File No. 130056

2
3 **Resolution adopting findings under the California Environmental Quality Act related to**
4 **modifications to the San Francisco Public Utilities Commission Water System**
5 **Improvement Program Calaveras Dam Replacement Project, located in Alameda and**
6 **Santa Clara Counties, including the adoption of a mitigation monitoring and reporting**
7 **program and a statement of overriding considerations; and directing the Clerk of the**
8 **Board of Supervisors to notify the Controller of this action.**

SAN FRANCISCO PLANNING DEPARTMENT

Addendum Date: December 13, 2012
Case No.: **2005.0161E**
Project Title: **Calaveras Dam Replacement Project**
EIR: 2005.0161E, certified January 27, 2011
Project Sponsor: San Francisco Public Utilities Commission
Lead Agency: San Francisco Planning Department
Staff Contact: Chris Kern – (415) 575-9037
chris.kern@sfgov.org

Figure 1
Cross-Section of the Left Abutment

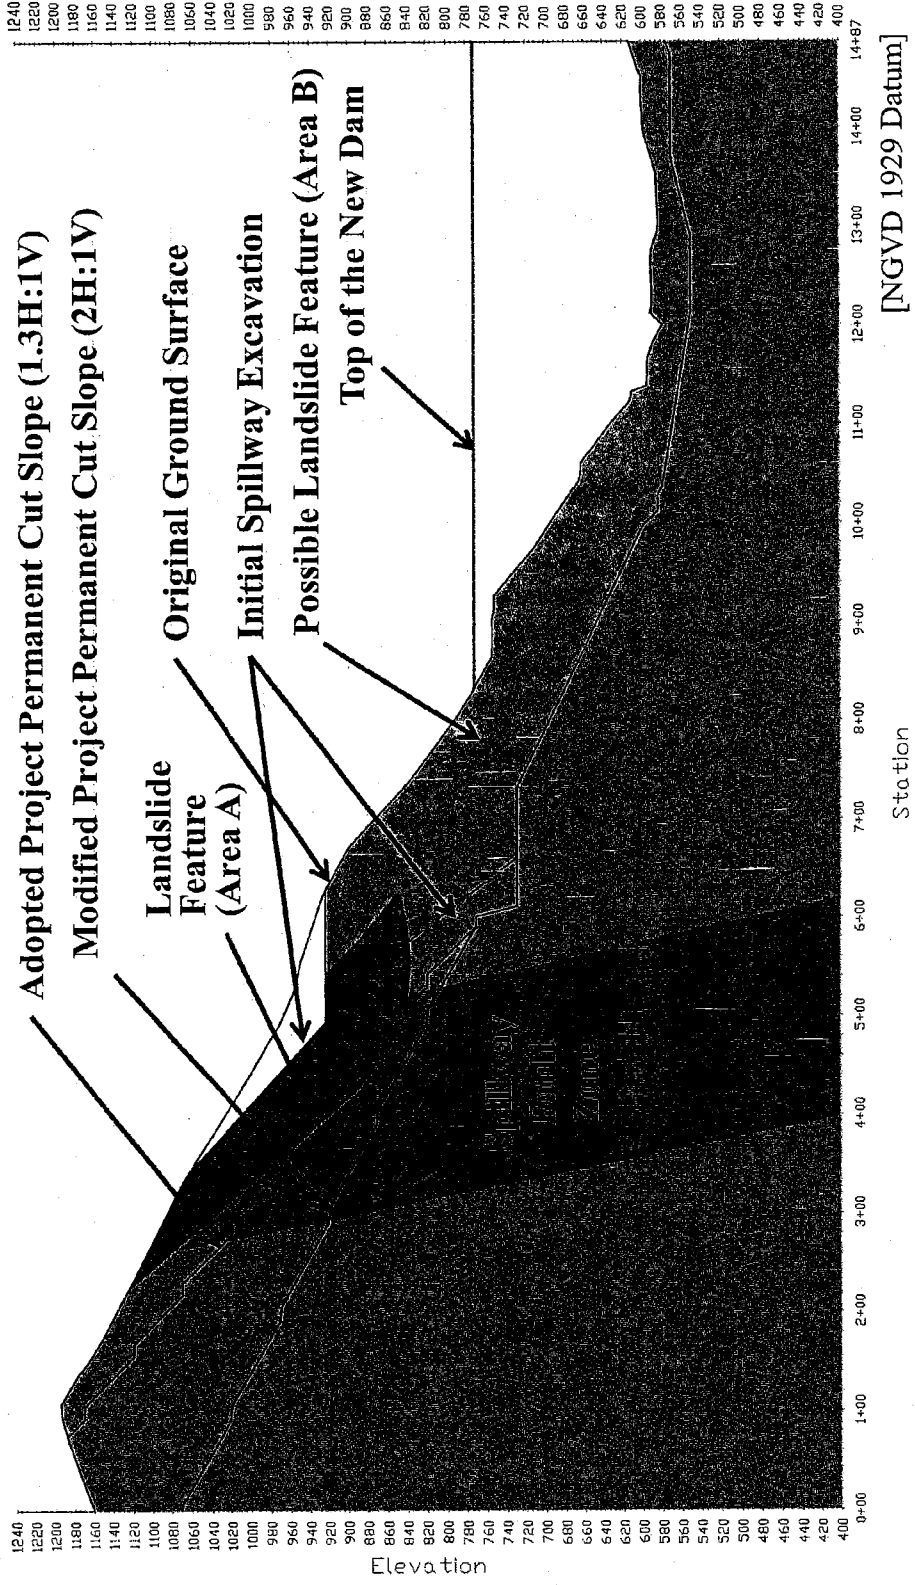
To address the newly discovered landslide hazard, the SFPUC proposed to layback (flatten) the left dam abutment in Observation Hill from the originally designed 1.3:1 slope to an overall slope of 2:1. As documented in Minor Project Modification (MPM) No. 18, on June 25, 2012, the Planning Department reviewed this proposed project modification and concurred with the SFPUC's determination that the proposal to layback the left dam abutment slope from 1.3:1 to 2:1 would not deviate from the adopted project such that it would result in any new significant impacts beyond those identified in the EIR or substantially increase the severity of a significant impact, and that no new mitigation measures would be required (see Appendix A).

In July 2012, the SFPUC initiated a geological and geotechnical study⁵ to further evaluate the slope instability hazard affecting the left dam abutment excavation. The study found the presence of one landslide feature (Area A) and another possible landslide feature (Area B) in the spillway cut slope in Observation Hill (see **Figure 1**). The study also found that the Spillway Fault Zone, a zone of sheared and broken rock along the trace of the Spillway Fault, was much wider than originally considered during design. Due to the presence of the Area A landslide feature and the wider Spillway Fault Zone, the study recommended additional excavation of the left abutment and grading of Observation Hill from its original design slope of 1.3:1 to a less steep 2:1 slope as described under MPM No. 18 (see **Figure 1**).

Figure 2
Adopted Project Components

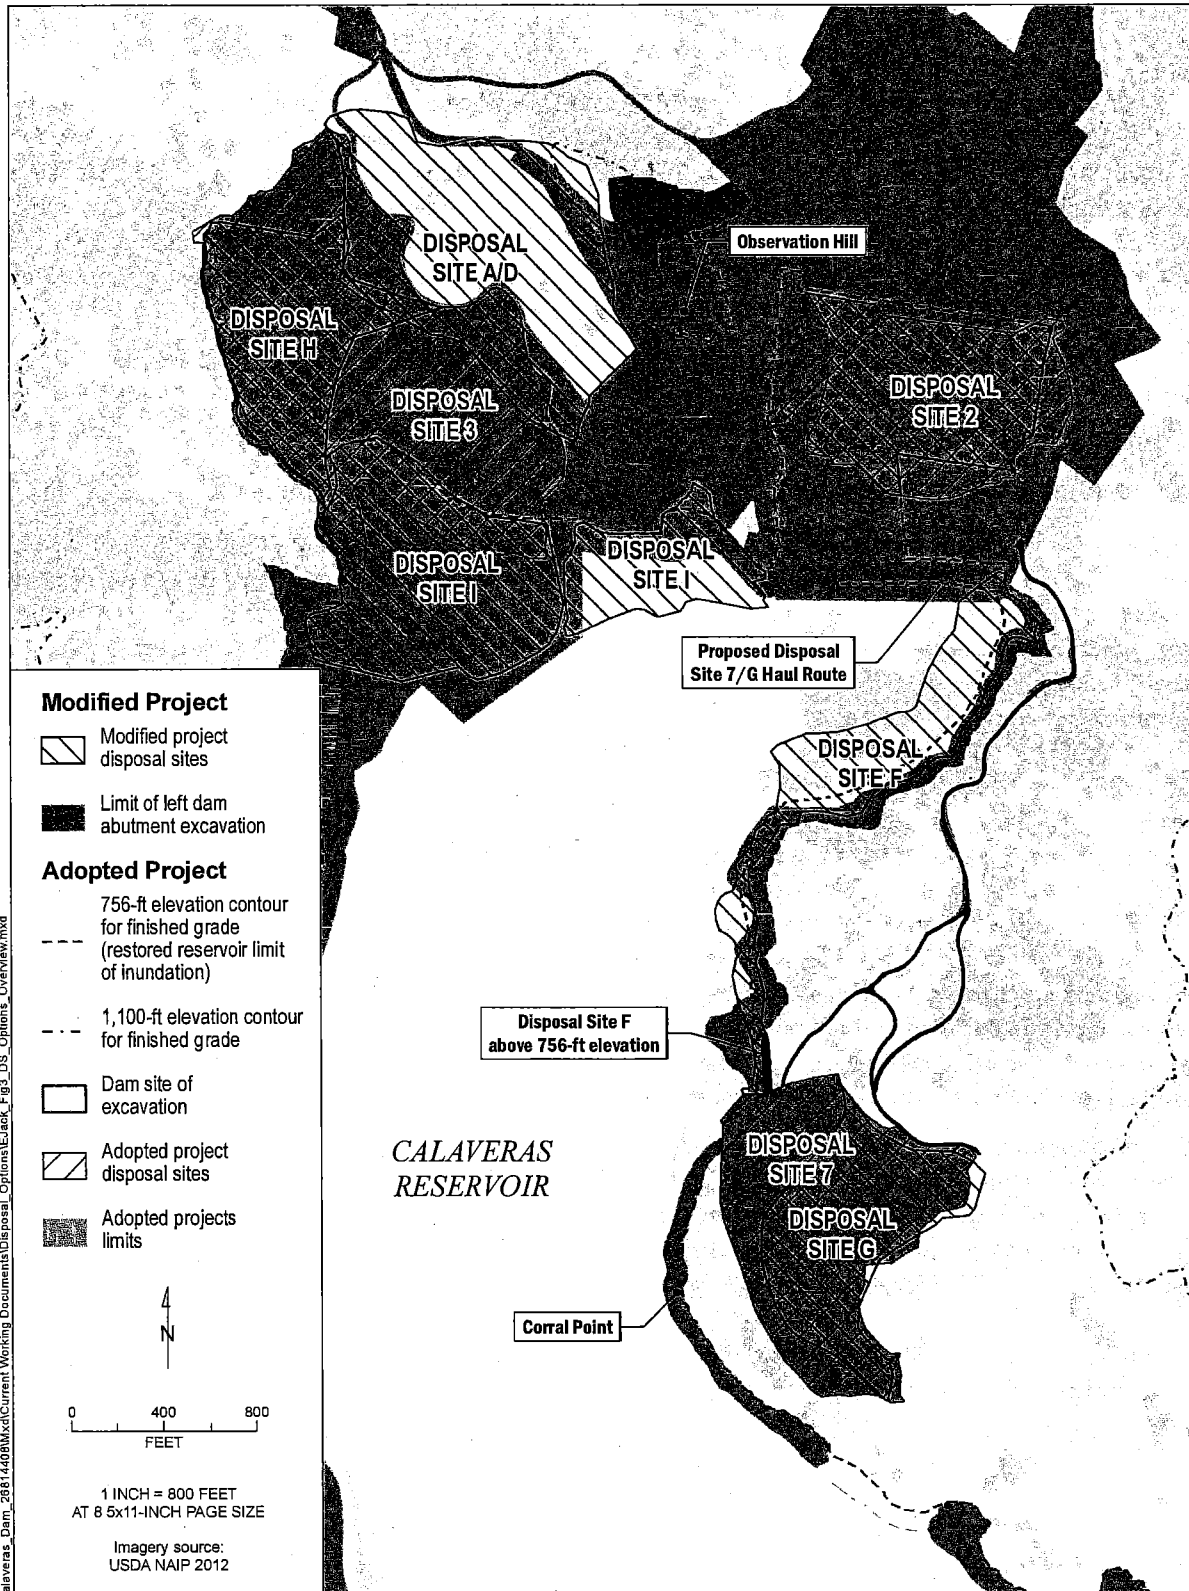
The disposal sites described in the EIR (Disposal Site 2, Disposal Site 3, and Disposal Site 7, with a combined capacity of approximately 4.44 million cubic yards), do not have sufficient excess capacity for the additional spoils that would be generated by the proposed excavation and grading of the left dam abutment (see **Figure 2**). Reserve Disposal Site 5 is located at the south end of the reservoir as shown in **Figure 2**, but would not be available until after clay materials have been excavated from Borrow Area E/Disposal Site 5 for the dam core, which is after spillway excavation is essentially complete. Because of this timing/sequencing constraint and the distance from the dam construction site, Reserve Disposal Site 5 is not considered a suitable option for the additional spoils. Consequently, SFPUC has identified five new disposal sites for the increased spoils—Disposal Sites A/D, F, G, H, and I (see **Figure 3**) could provide the required additional capacity along with a small contingency. The capacity and acreage of each site is listed in **Table 2**. As shown on Table 2, the total acreage associated with the new disposal sites is approximately 86.5 acres, including about 29.1 acres outside of the adopted project work limits.

In addition to the five new disposal sites, the SFPUC proposes to expand the capacity of Disposal Site 2 from 900,000 cubic yards as described in the EIR for the adopted project to 1.3 million cubic yards. Disposal Site 2 is located in the area between the existing dam (which would serve as a cofferdam during construction) and the replacement dam. As shown on **Figure 3**, all of the additional spoils proposed to be placed at this site would be located within the 13.9-acre portion of the site that would be below the 756-foot future inundation level of the restored reservoir. As the full scope of the project modifications required to address the landslide hazards was developed, the work proposed under MPM Nos. 18, 19, and 20 was further refined and incorporated into the project modifications addressed in this addendum and further described below.
